# SPI Guide for W3150A+ & W5100

(\* including all NM modules and Evaluation Board using W3150A+ or W5100)

EX 1) By using inverter

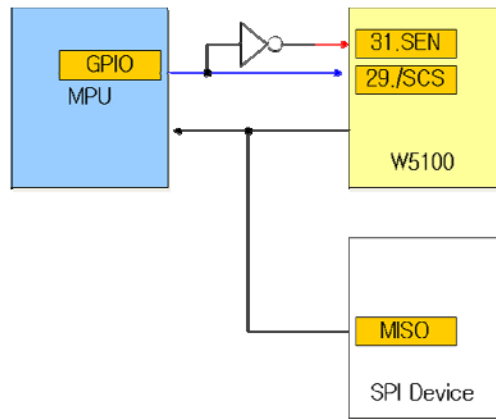
When using SPI mode of W3150A+ or W5100, MISO output is driven even though /SCS is asserted high. When SPI master (normally MCU) reads or writes another SPI device on the SPI BUS, it can't be normally processed. If there is not any other device on the SPI BUS, there is not any problem in read and write.

When access to another device on the SPI BUS, assert the SPI\_EN pin of W3150A+ or W5100 as low first and access other devices. When access W3150A+ or W5100 again, the SPI\_EN pin should be high.
